PLANNING AND ZONING COMMISSION AGENDA

STAFF REPORT
KETCHUM PLANNING AND ZONING COMMISSION
REGULAR MEETING OF FEBRUARY 27, 2017

- PROJECT:** Argyros Performing Arts Center zoning code text amendment request to amend Title 17, Zoning Regulations, Chapter 17.125, Off Street Parking and Loading

STAFF REPORT
KETCHUM PLANNING AND ZONING COMMISSION
REGULAR MEETING OF February 27, 2017

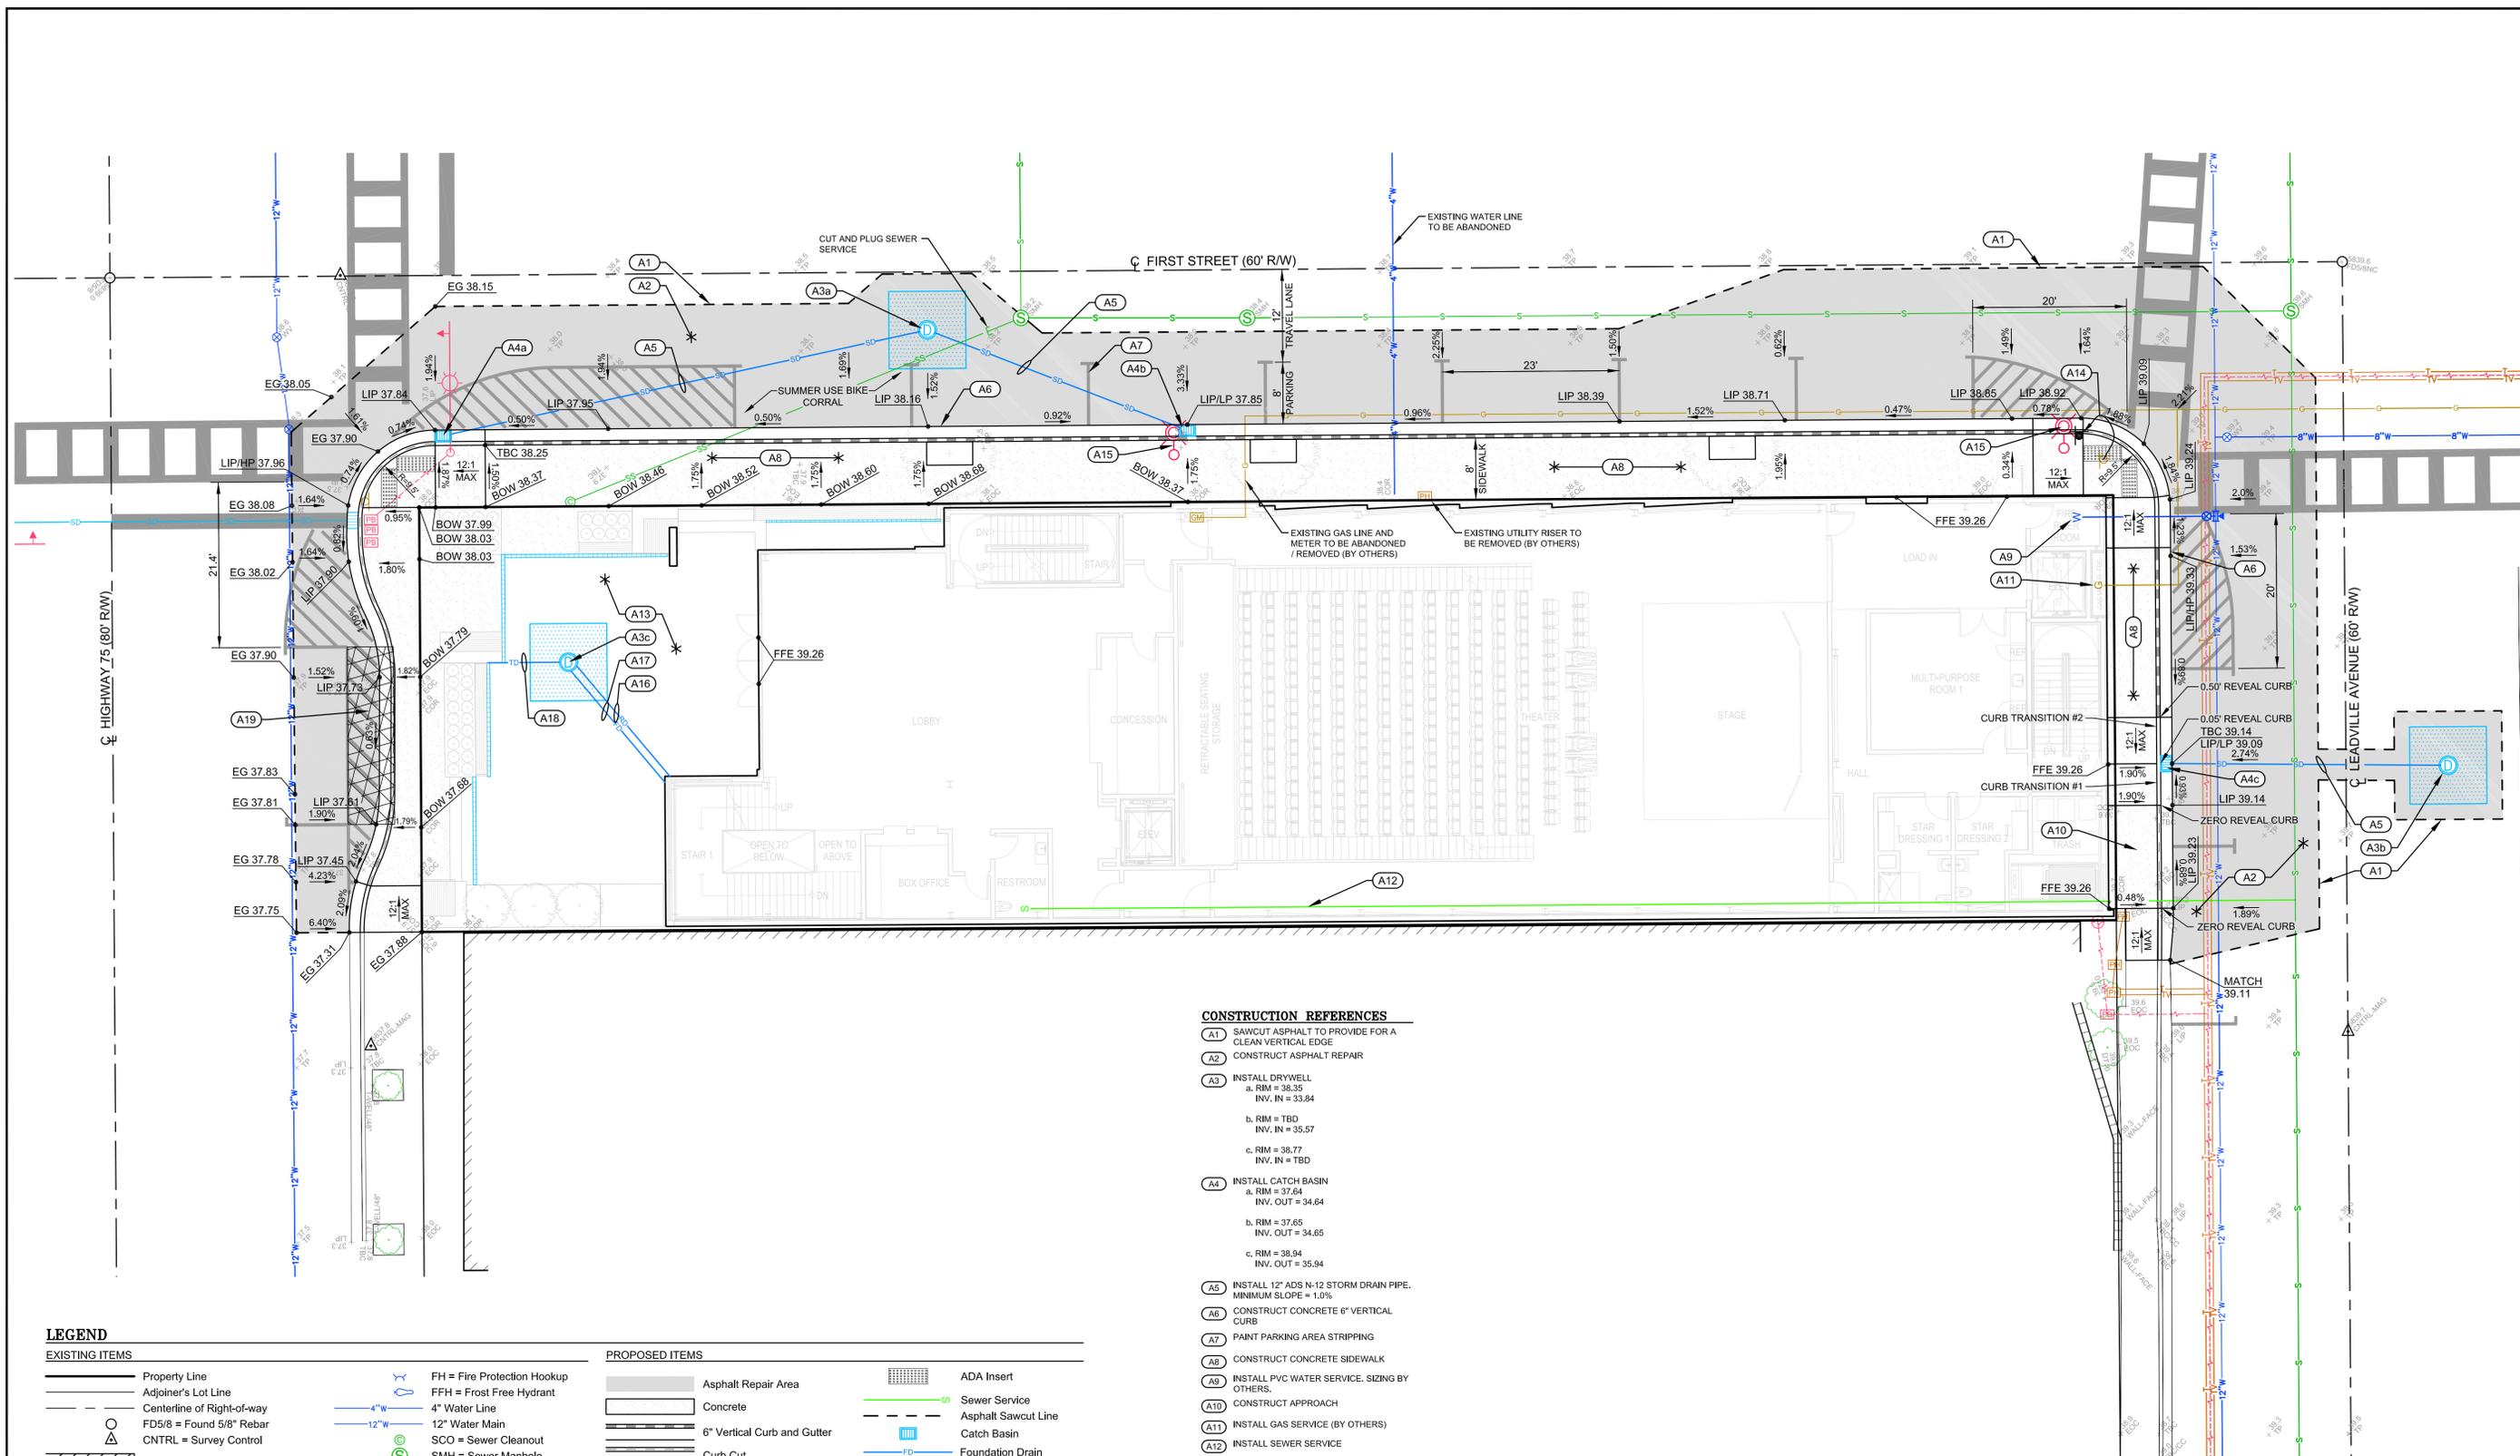
<input checked="" type="checkbox"/>	<input type="checkbox"/>	<p>Public Works: Streets Department: Looking at the civil plans, the grades for the sidewalk curb and gutter in several sections do not meet city standards. After meeting with Galena several times to try and improve the grades, I understand this particular site has constrictions that limit the ability to get grades that will meet our code. Although proposed grading does not meet this standard of slopes less than .5%, I believe the applicant has done their best to try.</p>
<input checked="" type="checkbox"/>	<input type="checkbox"/>	<p>Utilities: The property is currently served off of a fire line connecting off of Main St / SH 75. If it is not used as indicated it will need to be cut and capped in place at the fire line valve in the street. The current use is served from a 1" domestic meter off the fire line. When the new building is built, that meter will have to be replaced per DEQ standards at the owner's expense. No impact fees will apply unless meter size is increased. Please show the new fire line size on future drawings.</p> <p>There is currently an old KSW 4" water line that terminates at the property line with a circulation point frost free hydrant and dry well. If this circulation point is to be abandoned the KSW line will need to be cut and capped with a circulation frost free and dry well provided in a point safe from traffic and snow plows as approved by the Water supervisor. All sewer connections will be protected during demo, and any that are not used with the new construction will need to be capped at the property line.</p>

LANDSCAPE PLAN

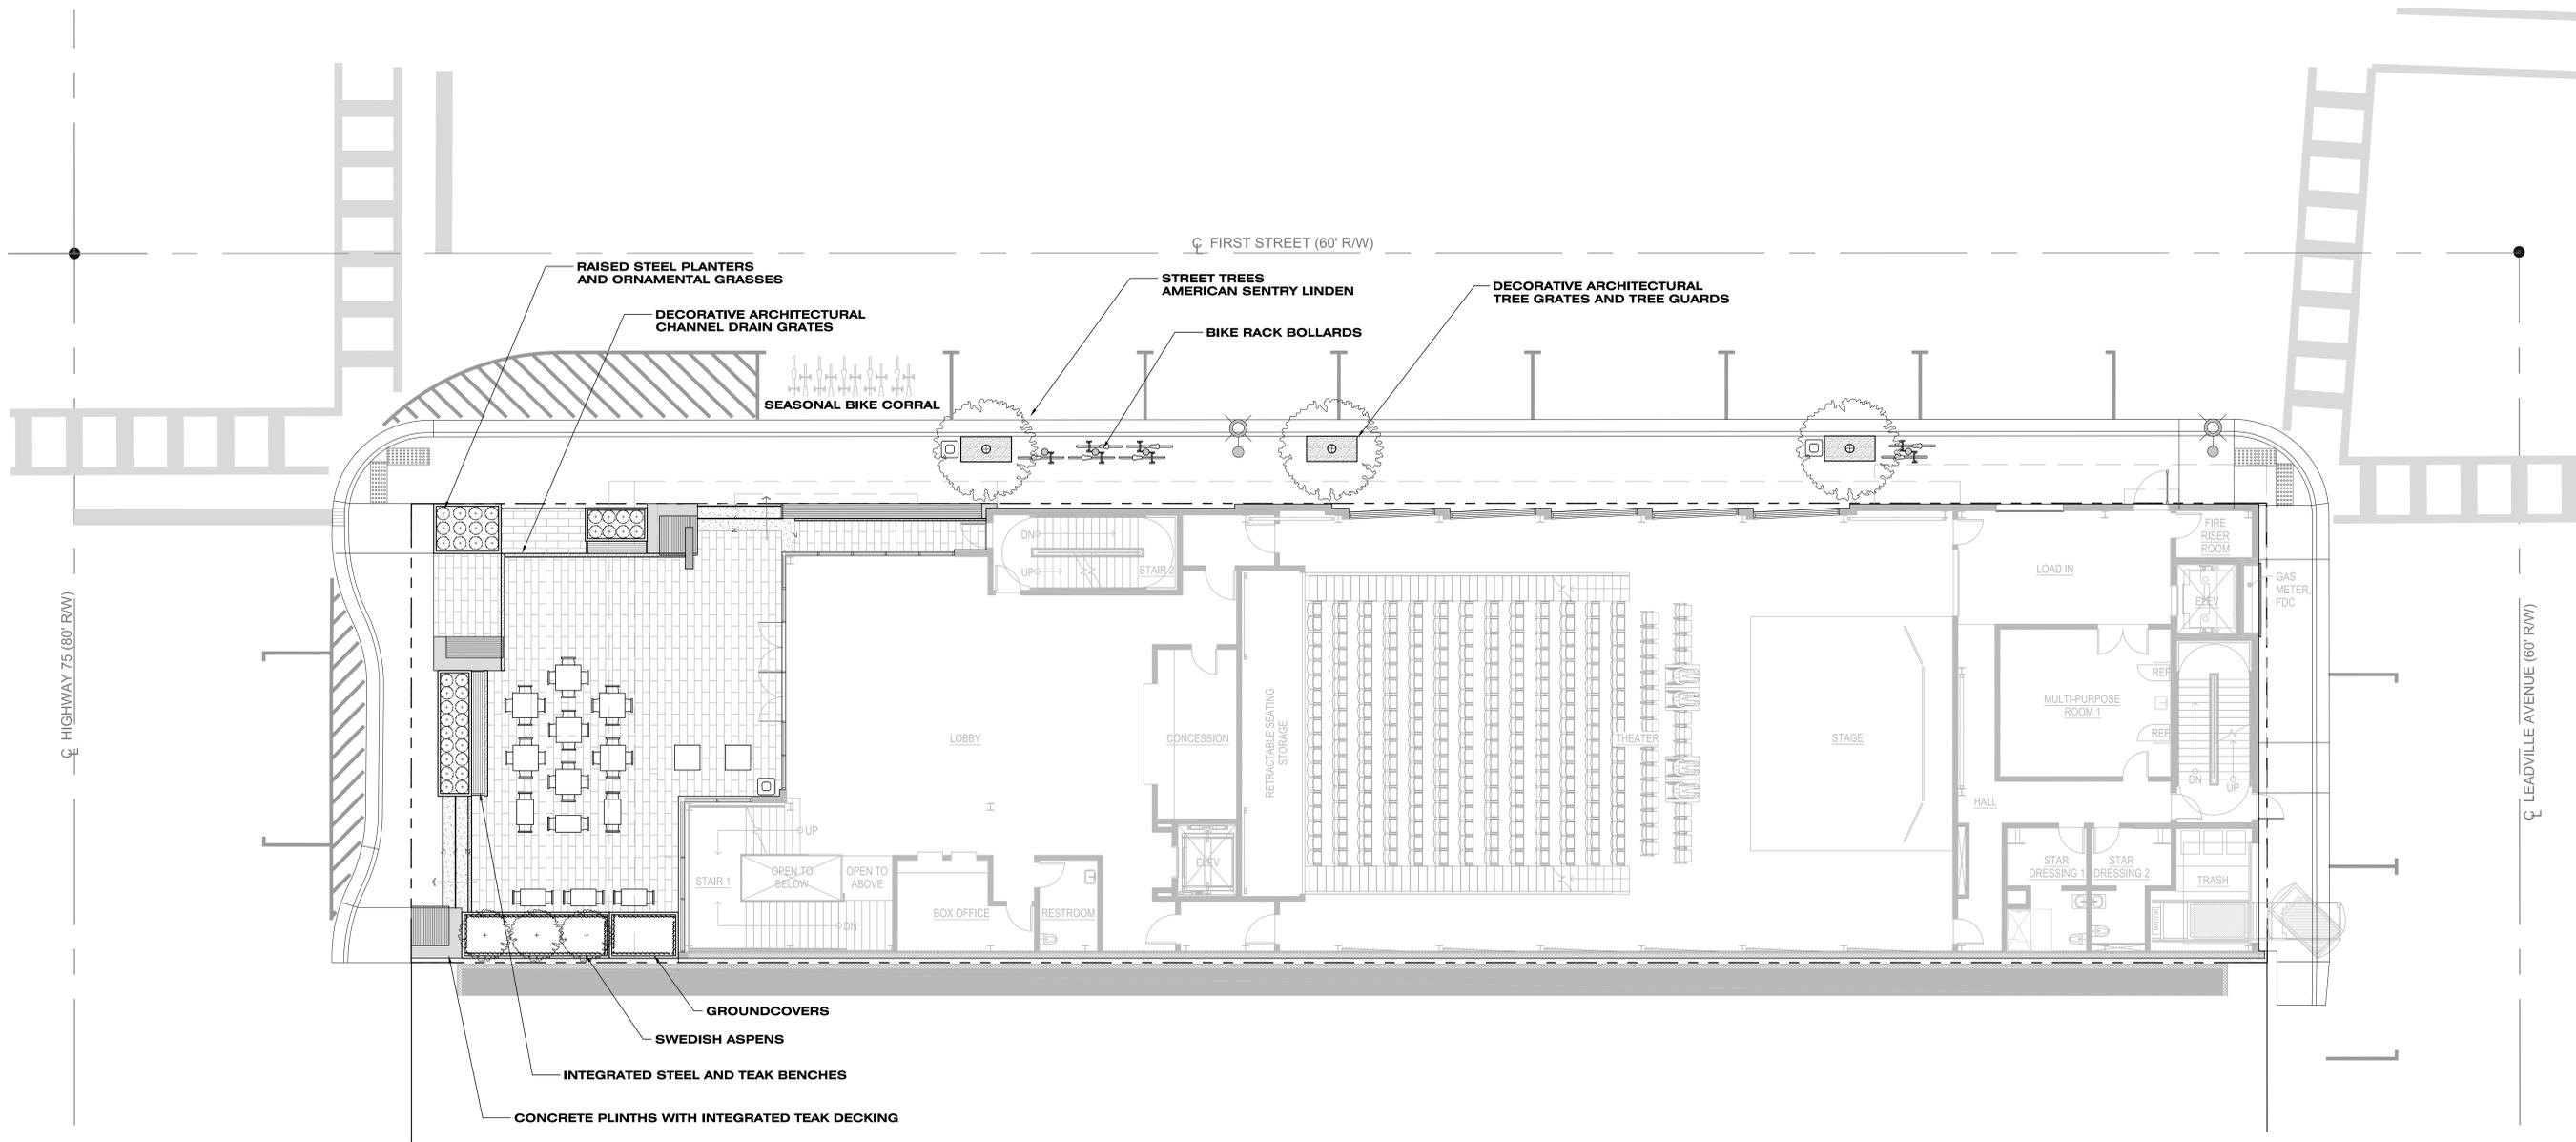
<i>Staff Comments</i>	<i>This is an urban downtown site and landscaping will be comprised of street trees and planter boxes. Street trees and plantings have been reviewed and approved by the City Arborist. See Table 1 for further comment from the City Arborist.</i>
<input checked="" type="checkbox"/>	<input type="checkbox"/>	<input type="checkbox"/>	17.96.060(I)(3)	All trees, shrubs, grasses and perennials shall be drought tolerant. Native species are recommended but not required.
			<i>Staff Comments</i>	<i>The City Arborist has reviewed the proposed trees, shrubs, grasses and perennials and has no concerns at this time.</i>
<input checked="" type="checkbox"/>	<input type="checkbox"/>	<input type="checkbox"/>	17.96.060(I)(4)	Landscaping shall provide a substantial buffer between land uses, including, but not limited to, structures, streets and parking lots. The development of landscaped public courtyards, including trees and shrubs where appropriate, shall be encouraged.

<i>Staff Comments</i>	<i>The applicant is proposing three-street trees along First Street East, which are proposed to be placed in tree wells and covered by tree grates which will be approved by the City Engineer. The City Arborist has encouraged the applicant consider utilizing Silva Cell technology for the street trees. This technology is known method to both enhance tree vitality and contribute to storm water management. For further comment see Table 1.</i> <i>The applicant is proposing that the on-site swedish aspens be located in a low planter box along the south property line to screen the plaza from the existing Kentwood Lodge wall. Both the City Arborist and City Engineer have reviewed the Landscape plans and have no comment regarding the tree placement at this time.</i>
<input type="checkbox"/>	<input type="checkbox"/>	<input checked="" type="checkbox"/>	17.96.070(D)(3)	The city arborist shall approve all parking lot and replacement trees.

<i>Staff Comments</i>	<i>The three (3) proposed trees located along First Street East will be placed in tree wells and covered by tree grate. The final tree grate design shall be approved upon final inspection and prior to the issuance of a Certificate of Occupancy. The applicant is proposing that the on-site swedish aspens be located in a low planter box along the south property line to screen the plaza from the existing Kentwood Lodge wall. Both the City Arborist and City Engineer have reviewed the Landscape plans and have no comment regarding the tree placement at this time. Additional on-site planters are proposed within the plaza which will contain ornamental grasses.</i>
<input checked="" type="checkbox"/>	<input type="checkbox"/>	<input type="checkbox"/>	17.96.070(F)(1)	One (1) bicycle rack, able to accommodate at least two (2) bicycles, shall be provided for every four (4) parking spaces as required by the proposed use. At a minimum, one (1) bicycle rack shall be required per development.
